**Inoperative Windshield Washer –
 Operated While Frozen –
 Upgrade Fuse To 15 amp**

MODEL 2000-01 MY
S-TYPE

VIN L00001-L86901

ILLUSTRATION 1

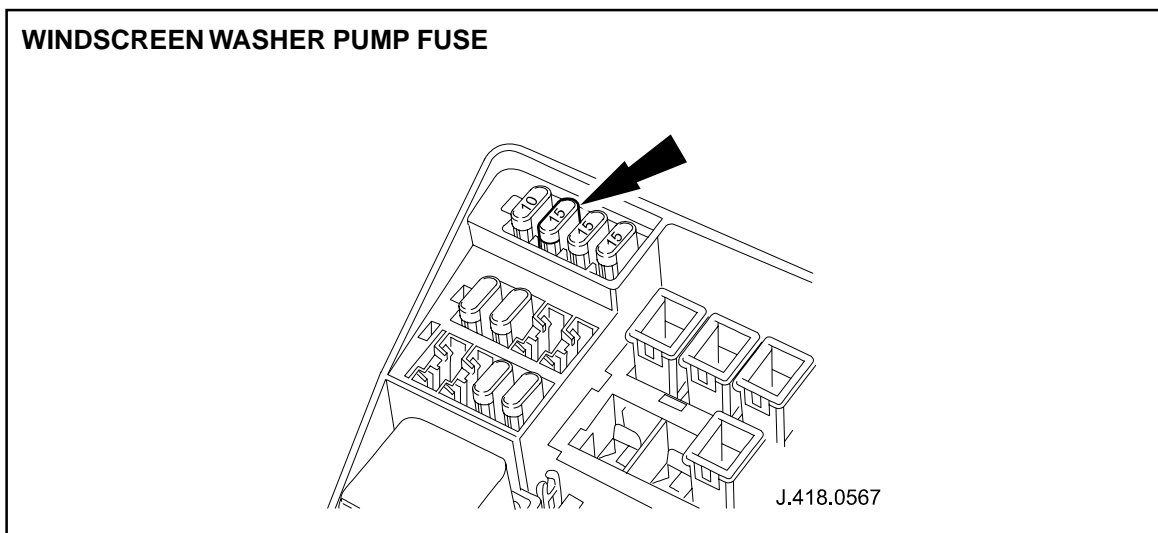
Owners of some 2000-01 MY S-TYPE vehicles within the above VIN range, may experience an inoperative windshield washer system after attempting to operate the systems while it was frozen.

In such cases only, the 10 amp fuse can be upgraded to a 15 amp fuse.

1. Open hood and place covers over fenders.
2. Remove engine compartment fuse box cover.
3. Remove windshield washer pump fuse (10 amp, position 2).

In case of a customer complaint of the above condition on a 2000-01 MY S-TYPE vehicle, replace the 10 amp fuse for the windshield washer system with a 15 amp fuse.

4. Install 15 amp fuse in position 2 (Illustration 1).
5. Install engine compartment fuse box cover.
6. Remove fender covers and close hood.
